Service-Information ASWO #W153170

Version 1 / 30.01.2023

During production the manufacturer changed the main body and battery pack, therefore two different versions of the battery are in the field. The newer version is called "Type D"

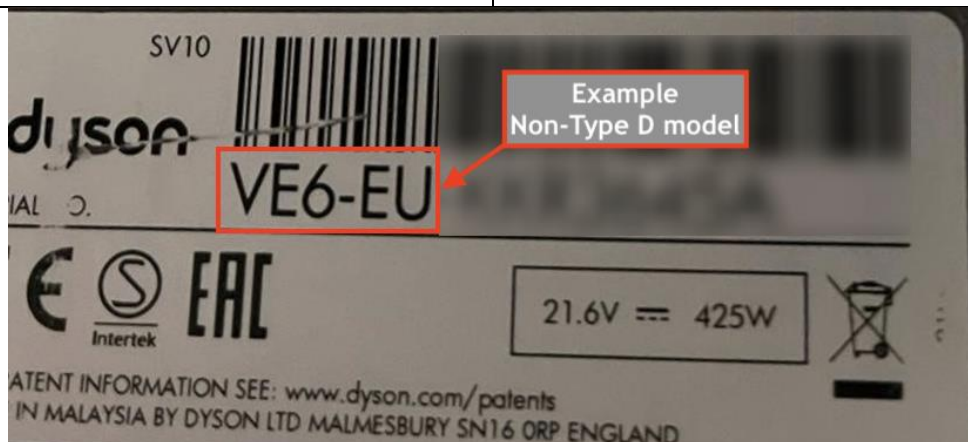
According to manf. the newer main body/power pack are not retro-fit with the earlier main body/power pack.

That means you can not use a Type D battery in the old main body!

**V8 (SV10) battery
S/N begins with VE6-EU or RA5-UK**

**can NOT be replaced with
Type D battery**

**V8 (SV10) battery (Type D)
S/N begins with YH5-EU or YM8-UK**
